PLAN REVIEW SHEET

Petition:

2014-046

The Housing Partnership

Waiting Pad Detail

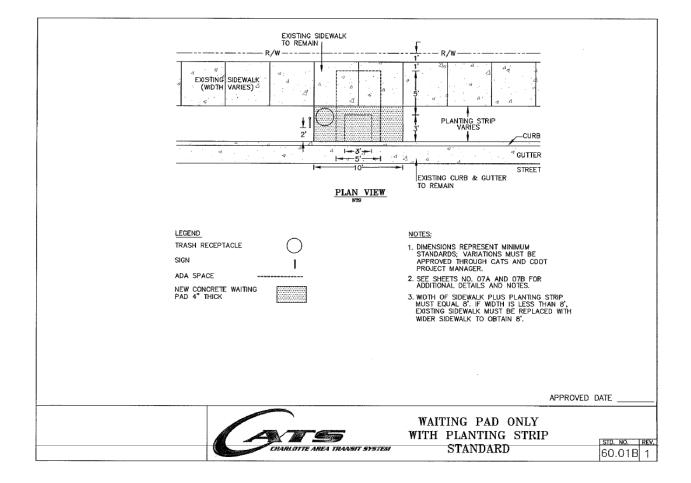
The Petitioner is requested to retain the existing bus stop and waiting pad along Statesville Avenue. If new curb is installed along Statesville Avenue, then the Petitioner is requested to upgrade the existing bus waiting pad to the attached standard. Below is an image of the standard detail (60.01B) for the requested bus stop pad.
